Subject: **Safety Recall 09C2**
EPA07 MBE 4000 Low Pressure Fuel Line

SAFETY RECALL BULLETIN

Subject: **Safety Recall 09C2**
EPA07 MBE 4000 Low Pressure Fuel Line

Figure 1 – Steel Low Pressure Fuel Line

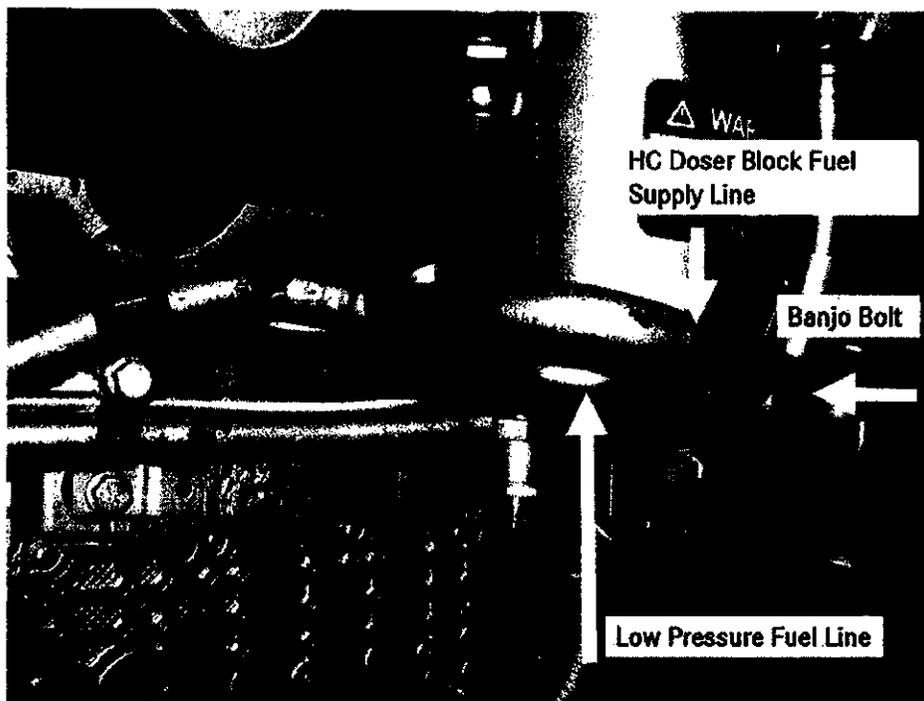
2. On the left side of the engine, **INSPECT** the low pressure fuel line that runs from fuel filter housing to the left front of the cylinder block. Reference Figure 1 for the location and appearance of the unpainted **NEW** steel fuel line.
 - a. If it is an unpainted steel line, then it does **NOT** need replacing. Go to the Corrective Procedure for **Item Two** starting on page five.
 - b. If it is a plastic line (painted or unpainted), then it **WILL** need to be replaced. Go to step 3.

3. **REFERENCE** 18SP660 in the service kits for installation instructions on the new steel low pressure fuel line and how to inspect the fuel filter housing thickness. New tool J-50161 Go/No-Go Gauge has been shipped to all DDC certified service locations for use in qualifying fuel filter housings on engines before serial number 0460888753. The gauge has been supplied and shipped at no cost. **REFERENCE** attached tool letter 09 TL-10.

Figure 2 – Main ECU Harness On Left Side Of Engine

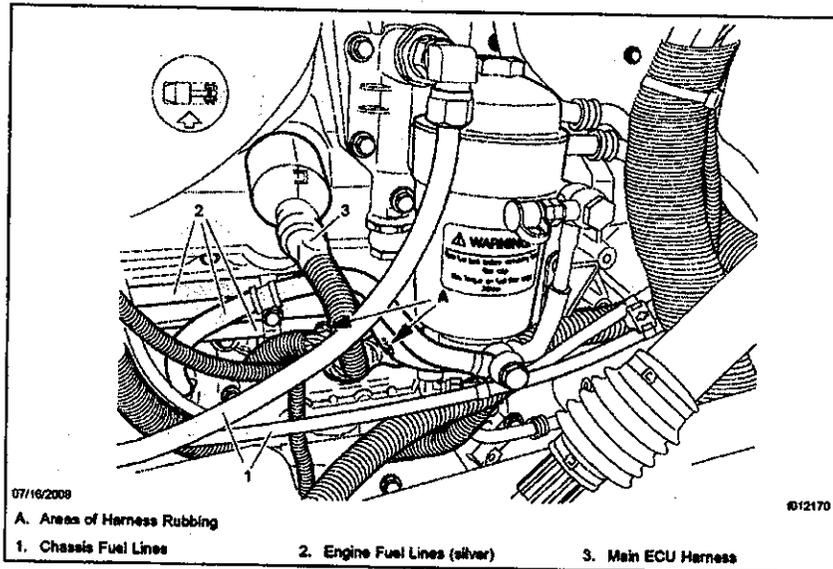
1. Find the main ECU harness on the left side of the engine. Reference Figure 2.

2. Disconnect the ECU harness from the engine.
3. If necessary, remove the left quarter fender. For instructions, see **Group 88** in the applicable vehicle service/workshop manual.
4. Remove the existing standoff bracket and cushion clamp that hold the ECU harness to the engine.
5. Remove any tie straps and extra loops of wiring as needed to gain more slack in the harness.
6. Install the new Z-bracket to the engine block where the previously removed bracket was.

Figure 3 – Rerouted Main ECU Harness and Fuel Lines

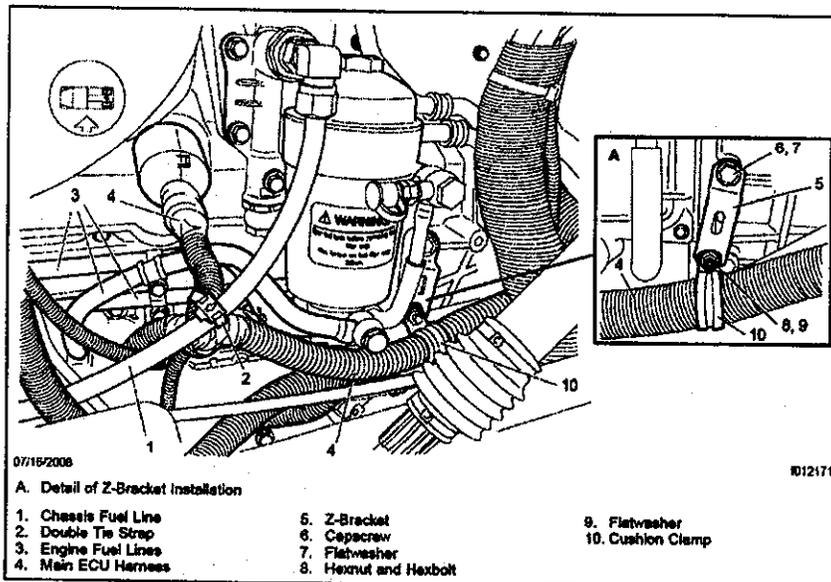
7. Reroute the ECU harness, making sure there is enough clearance between it and the engine fuel lines. Using a new cushion clamp and new fasteners, secure the harness to the new Z-bracket. Reference Figure 3.

8. Connect the engine sensor harness to the new air temperature sensor.
9. Connect the ECU harness to the engine.
10. Check the routing of the ECU harness in the engine compartment, and make sure it is not rubbing on any of the fuel lines. As needed, use double tie straps to separate the fuel line(s) from the harness.
11. Loop any extra length of harness wiring as needed, and secure with tie straps.
12. Install the quarter fender. For instructions, see **Group 88** in the applicable vehicle service/workshop manual.
13. Connect the batteries.
